Display

Date: **September 11, 1995**

Subject: **SHIELD PLATES FOR INTERFERENCE PROTECTION**

Model: **PVM-5041Q**

Figure 2

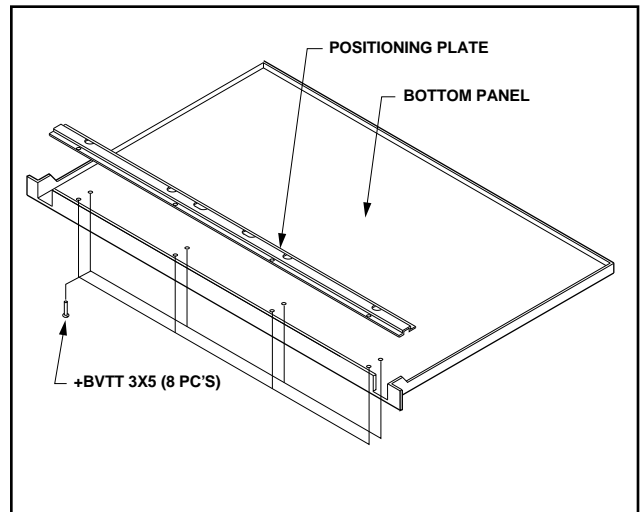
1. Remove positioning plate from bottom panel (Figure 2).

Figure 1

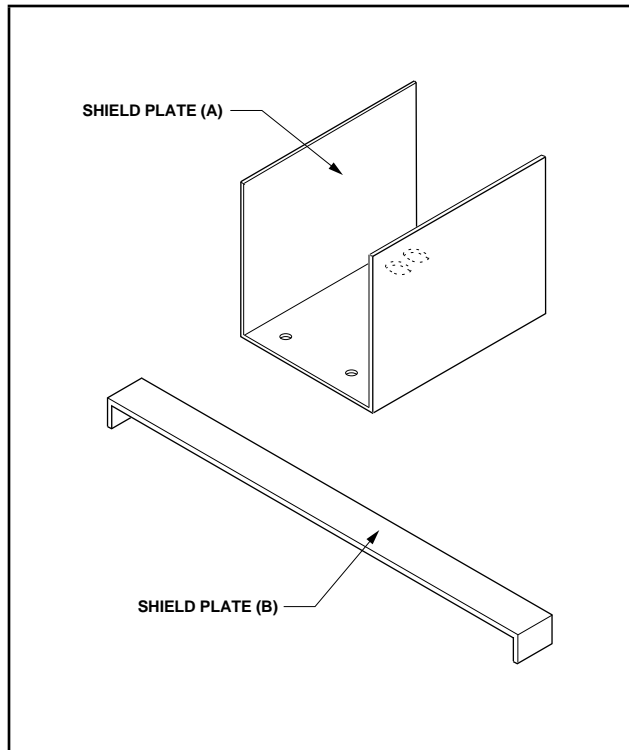
* Kit consists of 3 shield plates (A) and 1 shield plate (B) (see Figure 1).

Figure 3

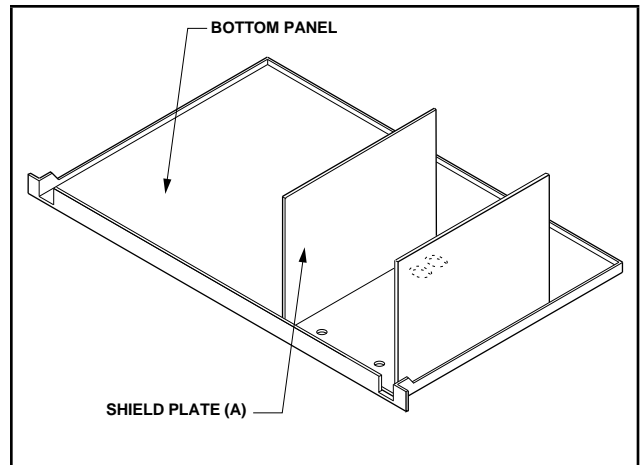
2. Install shield plate (A) (Figure 3.)

Figure 4

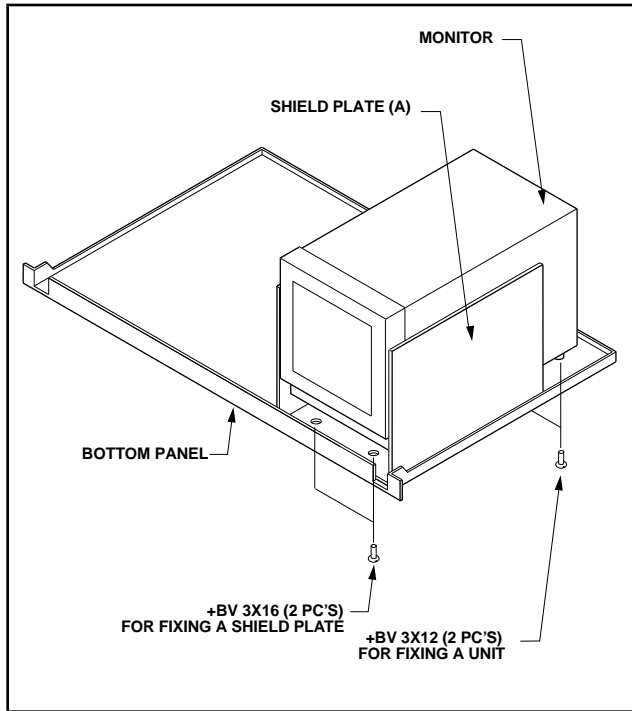
3. Install monitor in shield plate (A) and tighten shield plate (A) to the bottom panel. (See Figure 4). Install other monitors in the same manner.
4. Install shield plate (B) on monitors as shown in Figure 5.
